SUBJECT: FINAL SAFETY EVALUATION FOR LICENSING TOPICAL REPORT
NEDC-33353P, "LICENSING TOPICAL REPORT APPLICATION OF
GNF-ZIRON TO GNF FUEL DESIGNS" (EPID: L-2010-TOP-0003)

SUBJECT: FINAL SAFETY EVALUATION FOR LICENSING TOPICAL REPORT
 NEDC-33353P, "LICENSING TOPICAL REPORT APPLICATION OF
 GNF-ZIRON TO GNF FUEL DESIGNS" (EPID: L-2010-TOP-0003)
 DATE: MARCH 29, 2019

OFFICE OF NUCLEAR REACTOR REGULATION
DIVISION OF SAFETY SYSTEMS
SAFETY EVALUATION FOR GLOBAL NUCLEAR FUEL
LICENSING TOPICAL REPORT
NEDC-33353P REVISION 0, LICENSING TOPICAL REPORT
APPLICATION OF GNF-ZIRON TO GNF FUEL DESIGNS

Figure 3-1. Creep strain for Zircaloy-2, Ziron and Zr-2 High FeNi from pressurized cladding capsules irradiated in Plant K (Ref. 12) – 80 MPa hoop stress (top) and 150 MPa hoop stress (bottom).

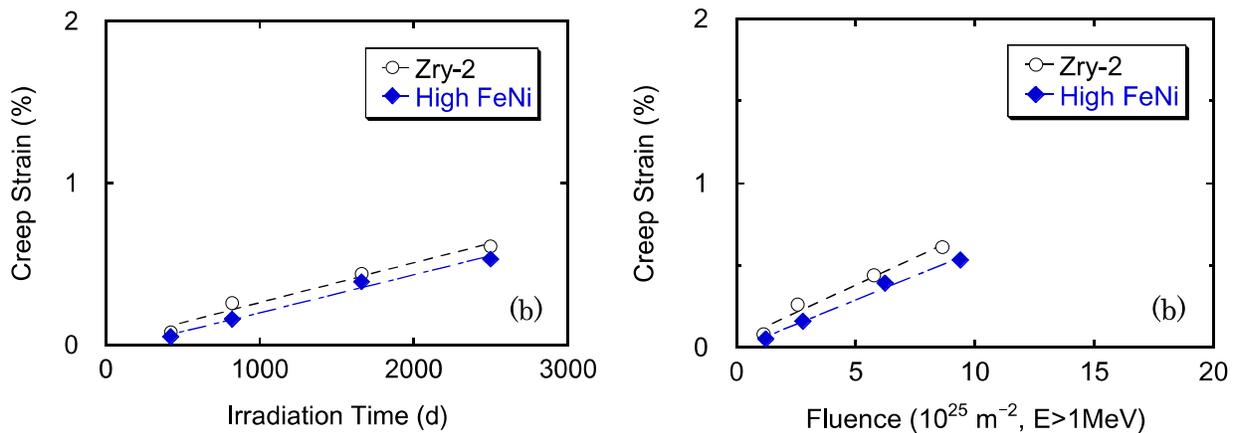
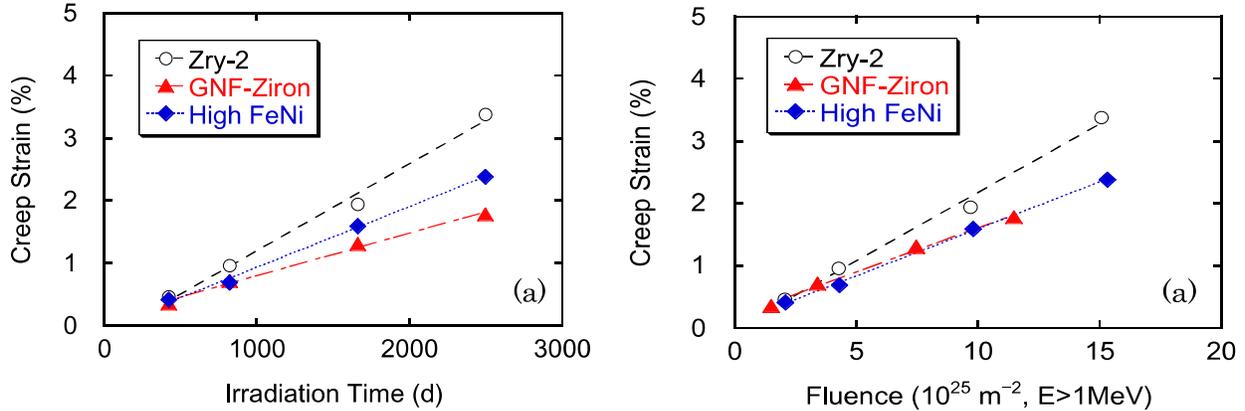
Figure 3-1 compares the creep strain measurements as functions of irradiation time and fluence. With respect to the 80 MPa capsules, the difference between Zr-2 and Zr-2 high FeNi was not significant, and it is expected that Ziron has similar creep behavior to the Zr-2 high FeNi, whereas for the 150 MPa capsules the creep rate for high Fe (Ziron) and high FeNi Zr-2 was about 15 percent lower than for Zr-2. In the LTR, GNF indicated that the [] since over the same period of irradiation (6 cycles, 2500 days), the Ziron cladding achieved []

Figure 3-3. Cycle Strain Amplitude as a Function of Cycle for 9x9 BWR Cladding (Ref. 12)

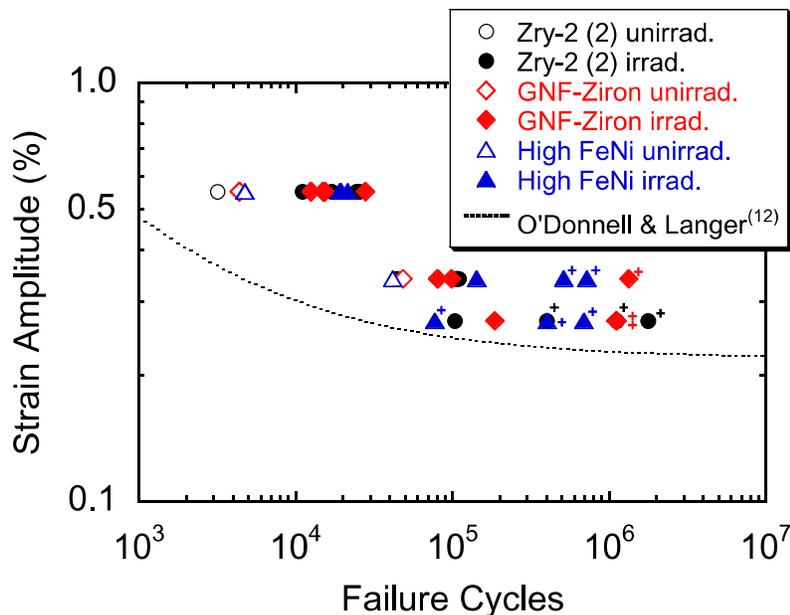
Evaluation: GNF has performed fatigue tests on Ziron that show the fatigue is somewhat below the best-estimate Langer-O'Donnell curve. GNF provided some results in the LTR (Figure B-8) and has published data in the literature (Ref. 12) shown in Figure 3-3. The data sit above the Langer-O'Donnell curve, and it demonstrates that Ziron has similar, or otherwise improved, fatigue resistance capability compared to that of Zircaloy-2.

The staff concludes that the design bases/criteria and evaluation methodology for cladding strain fatigue for Zircaloy-2 is acceptable for Ziron.
